U.S. NUCLEAR REGULATORY COMMISSION

STANDARD REVIEW PLAN

3.2.2 SYSTEM QUALITY GROUP CLASSIFICATION

DRAFT Rev. 2 - April 1996

FIGURE A-1 EVOLUTIONARY BWR MAIN STEAM SYSTEM QUALITY GROUP AND SEISMIC CLASSIFICATION DIAGRAM

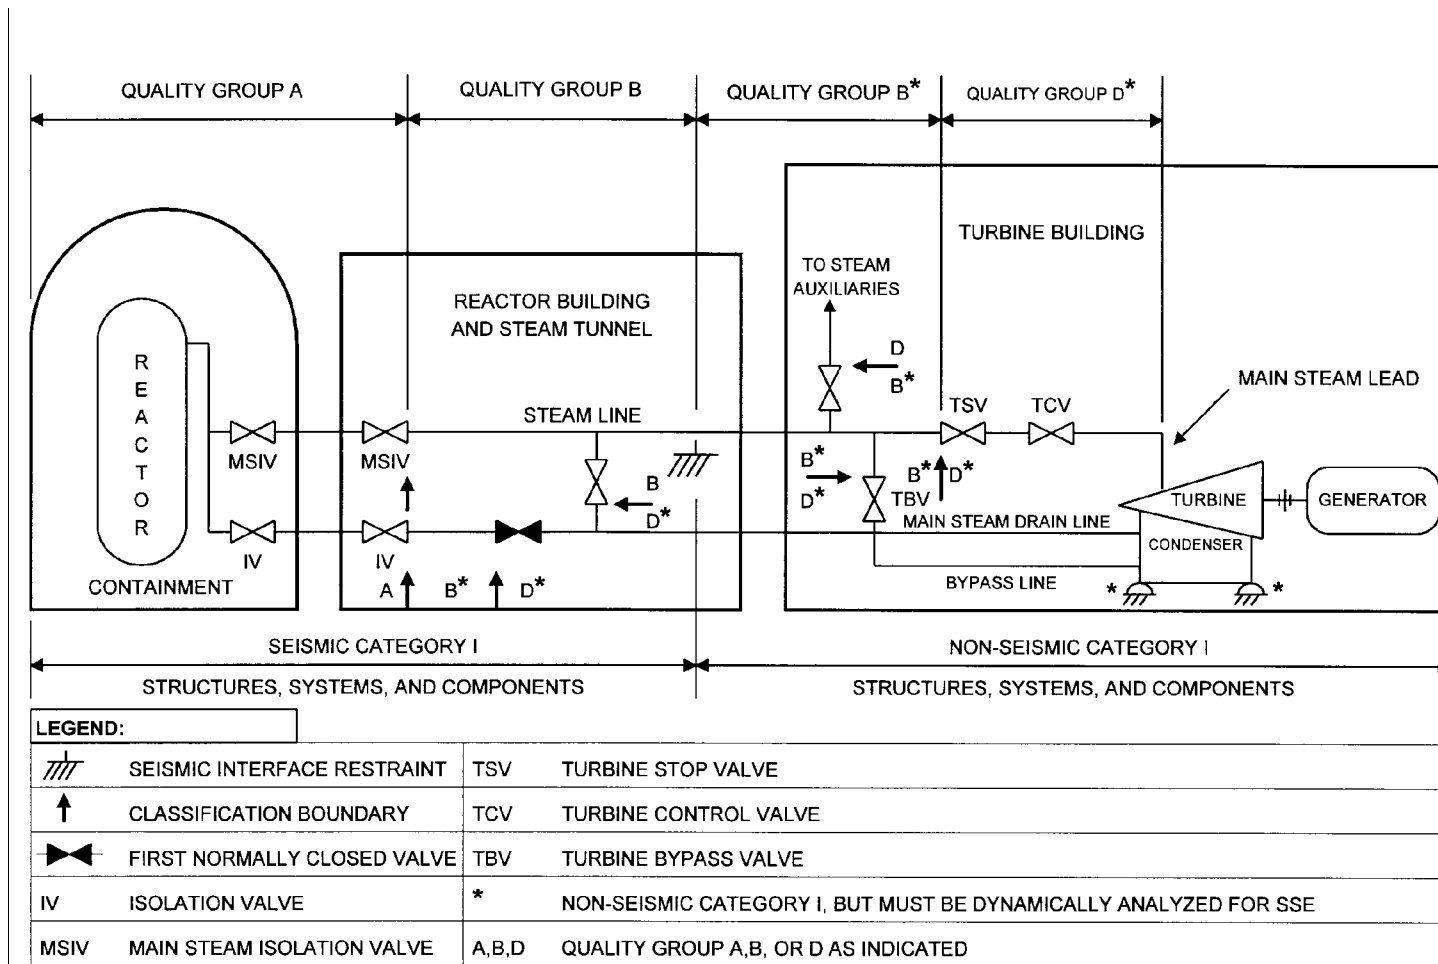
109.	Integrated Impact 1323	Added reference to classification criteria for BWRs without an MSIVLCS that take credit for fission product hold-up in the main steam lines. Also included new Figure A-1 at the end of Appendix A.

⁴ Acceptable design and classifications for BWR main steam piping and components, including those comprising main steam isolation valve leakage hold-up and retention paths, as illustrated in Figure A-1, are as follows:

b. The main steam line piping from the outermost containment isolation valve up to the seismic interface restraint should be classified as seismic Category I, as should connecting branch lines up to the first normally closed valve. The seismic interface restraint must provide a structural barrier between the seismic Category I portions of main steam piping in the reactor building and non-seismic Category I portions of such piping in the turbine building. The seismic interface restraint must be located inside a seismic Category I building. Main steam line piping from the seismic interface restraint up to, but not including the turbine stop valve (including branch lines to the first normally closed valve) and steam drain line piping from the outermost containment isolation valve to the condenser hotwell should be classified and analyzed as described in 4.c below. All pertinent quality assurance requirements of Appendix B to 10 CFR Part 50 apply to the main steam line piping from the seismic interface restraint up to, but not

including, the turbine stop valve (including branch lines to the first normally closed valve).
